SUBJECT: TECHNICAL SPECIFICATION CHANGE REQUEST TO ACHIEVE CONSISTENCY WITH PREVIOUSLY APPROVED CHANGES AND TO CLARIFY EXISTING REQUIREMENTS (TAC NO. 66553)

Re: Clinton Power Station, Unit No. 1

AMENDMENT TO FACILITY OPERATING LICENSE

SAFETY EVALUATION BY THE OFFICE OF NUCLEAR REACTOR REGULATION  
SUPPORTING AMENDMENT NO. 19 TO FACILITY OPERATING LICENSE NO. NPF-62

Figure 6.2.1-1 Corporate Structure Relative to Clinton Power Station Offsite Organization

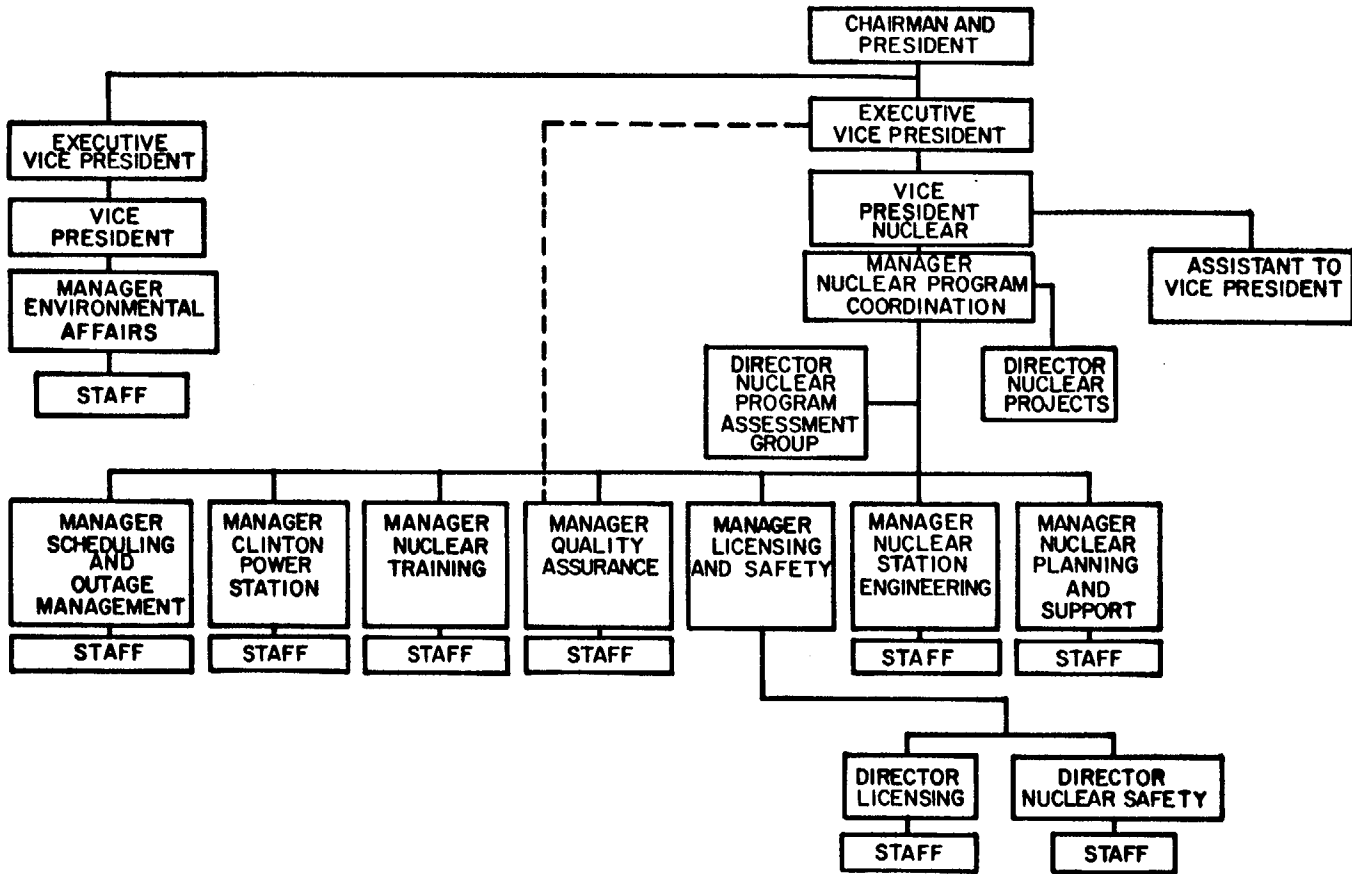
Figure 6.2.1-1 on page 6-3 would be modified to change the title from Director - Nuclear Training to Manager - Nuclear Training. Additionally, the box under the title Manager - Scheduling and Outage Management would be changed from "Operations" to "Staff." Section 6.3.1 on page 6-7 would be changed to delete the exception to ANSI/ANS 3.1-1978 for the Supervisor of Control and Instrumentation, delete the reference to the Radiation Protection Supervisor, and delete the sentence committing to meet or exceed the requirements contained in a March 28, 1980 letter issued by the NRC to all licensees. Section 6.4 on page 6-7 would be changed to rename the title Director Nuclear Training to Manager - Nuclear Training, delete the reference to meet the recommendations of Section 5.5 of ANSI/ANS 3.1-1978, delete the reference to meet the recommendations of Appendix A to 10 CFR Part 55, and delete all reference to text contained in the March 28, 1980 letter issued by the NRC to all licensees.

All of these changes are administrative in nature. On page 6-3, Figure 6.2.1-1, the title of Director - Nuclear Training is being upgraded to Manager - Nuclear Training to conform with the titles of all other positions in the figure that also report to the Manager - Nuclear Program Coordination. Similarly, the box under the Manager - Scheduling and Outage Management is being changed to read "staff" instead of "operations" to conform with the labels under all other manager positions.

Figure 6.2.2-1 Unit Onsite Organization

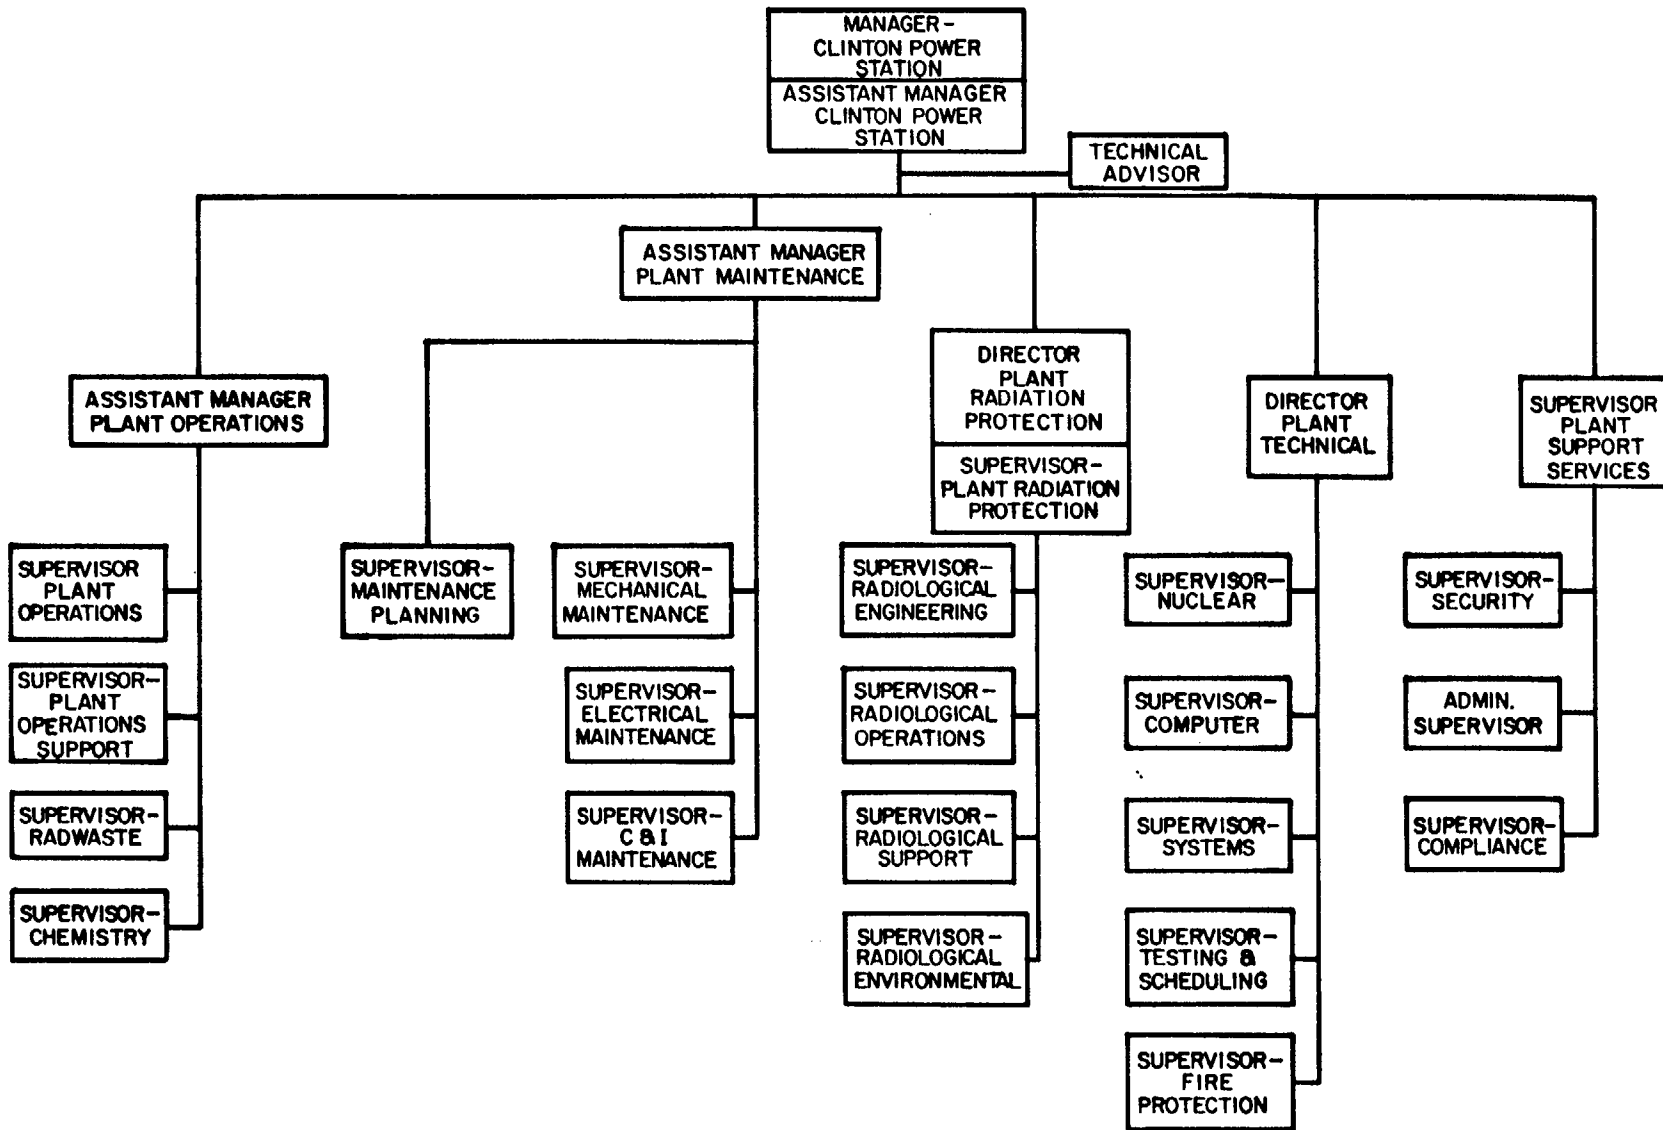
The proposed change would modify Figure 6.2.2-1, "Unit Onsite Organization" to delete asterisks used to indicate qualification requirements for various unit staff personnel. Additionally, the positions of Director - Plant Maintenance and Assistant Manager - Startup have been deleted due to company organizational restructuring.

The original figure contains asterisks which indicate that the position requires an SRO license next to the following positions: Assistant Manager - Plant Operations, Supervisor - Plant Operations, and Director - Plant Technical. These asterisks are being removed from the figure because the qualification requirements for personnel are also contained in

Technical Specification 6.3, "Unit Staff Qualifications," and in Chapter 13 of the FSAR; therefore, the asterisks are considered redundant. A reorganizational restructuring of Illinois Power Company has eliminated the positions of Director - Plant Maintenance and Assistant Manager - Startup. Clinton has completed initial Startup activities, and the Assistant Manager - Maintenance will now have the Supervisors of Mechanical, C&I, and Electrical Maintenance all report directly to him. These proposed changes are administrative in nature and do not impact the accident analysis, create the possibility of a new or different kind of accident, or involve a significant reduction in the margin of safety. Therefore the staff has determined that the proposed changes are acceptable.
